T/WALL TOP OF FOUNDATION WALL F.SLAB FIN. BASEMENT FLOOR SLAB U/FTG. UNDERSIDE FOOTING ELEVATION PART OF LOT 1 **CONCESSION 9** CITY OF CAMBRIDGE **REGIONAL MUNICIPALITY OF WATERLOO**

BARLASSINA CONSTRUCTION INC

PROJ. No. 21-35

LOT No. 113

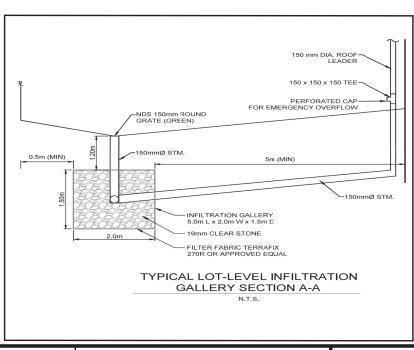
FINAL GRADING CERTIFICATE REQ'D BEFORE FINAL INSPECTION SIGN-OFF

CERTIFICATE OF U/S OF FOOTING ELEVATION AND P.ENG SOILS REPORT REQ'D AT FOOTING INSPECTION (see inspector)

P.ENG SOILS REPORT IS REO'D TO CONFIRM BEARING CAPACITY OF SOILS. SEE FIELD INSPECTOR

MIN. 4' FROST PROTECTION FOR ALL FOOTINGS

Clear stone must be used when the building separation on side yards is 1.5m or less, and must be inspected by the City prior to the placement of stone. The depth of the clear stone shall not be less than 150mm and placed on the geotextile

**ENSURE STEPS DO NOT** INTERFERE WITH GARAGE MAN DOOR LOCATION

LOT COVERAGE OK; LOT AREA OK; FRONT LANDSCAPING OK;

45 MINUTE RATED WALL WITH SIDE YARD < 1.2m
